World Forum for Harmonization of Vehicle Regulations

Working Party on General Safety Provisions

Proposal for Supplement 1 to the 03 series of amendments to UN Regulation No. 58 (Rear underrun protective devices (RUPDs))

Submitted by the expert from Finland*

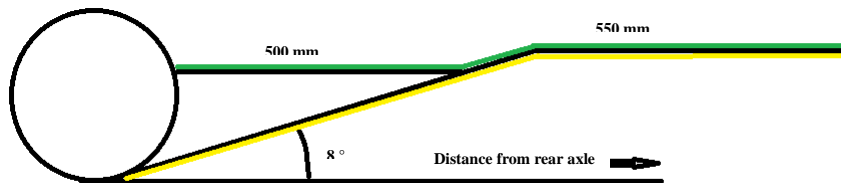
2. Paragraph 16.1. concerns the installation of RUPD. The current wording leads to the situation marked with yellow in the drawing below. A RUPD should be placed just behind the rear wheel and vertically near the ground level. The interpretation of Finland is that the position originally meant is marked with green in the drawing below. Thus the strikethrough text needs to be removed from paragraph 16.1.

"16.1. For vehicles of the categories N₂ with a maximum mass exceeding 8 t, N₃, O₃ and O₄, the ground clearance with respect to the underside of the protective device, even when the vehicle is unladen, shall not exceed:

- (a) 450 mm for motor vehicles and trailers with hydropneumatic, hydraulic or pneumatic suspension or a device for automatic levelling according to load. In any case, a departure angle up to 8° according to ISO 612:1978 with a maximum ground clearance of 550 mm shall be deemed to satisfy the requirements.
- (b) 500 mm ~~or a departure angle according to ISO 612:1978 of 8°, whichever is less~~, for vehicles other than those in (a) above. In any case, a departure angle up to 8° according to ISO 612:1978 with a maximum ground clearance of 550 mm shall be deemed to satisfy the requirements.
